## PARTS & SERVICE NEWS

REF NO.	AA00105		
DATE	June 27, 2000

**SUBJECT:** NEW FUEL GAUGE FOR FUEL TANK

**PURPOSE:** To introduce an improved fuel gauge for more accurate indications for use with

Fig. 5

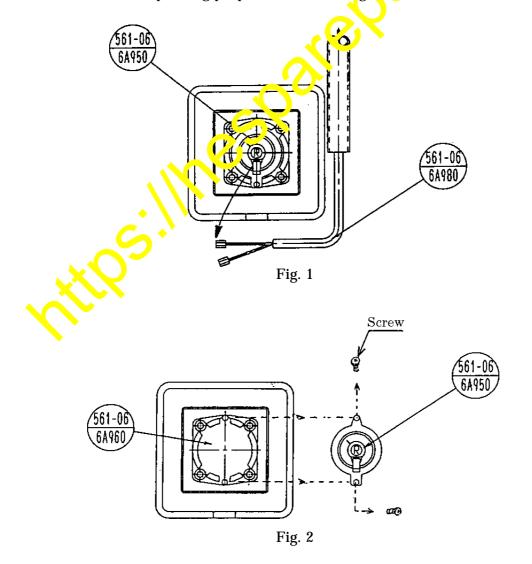
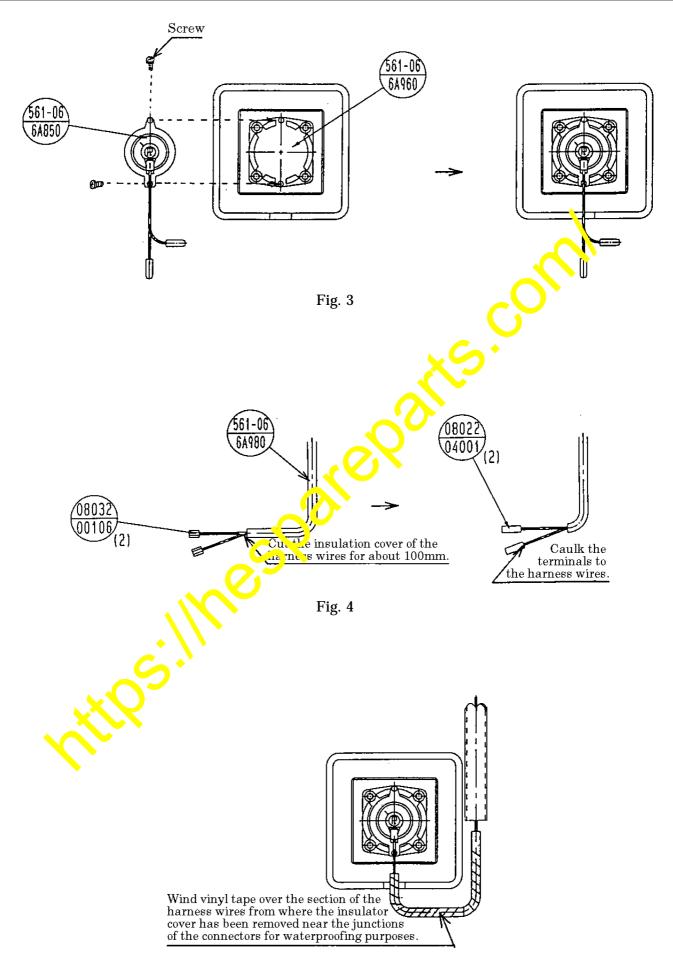
At this time, cut the insulation cover of the harness wires for about 100mm before installing the terminal. (Refer to Fig. 4.)
- 6) Connect the wire harness to the transmitter and wind viryl tape over the section of the harness wires from where the insulator cover has been removed near the junctions of the connectors for waterproofing purpose. (Refer to Fig. 5.)
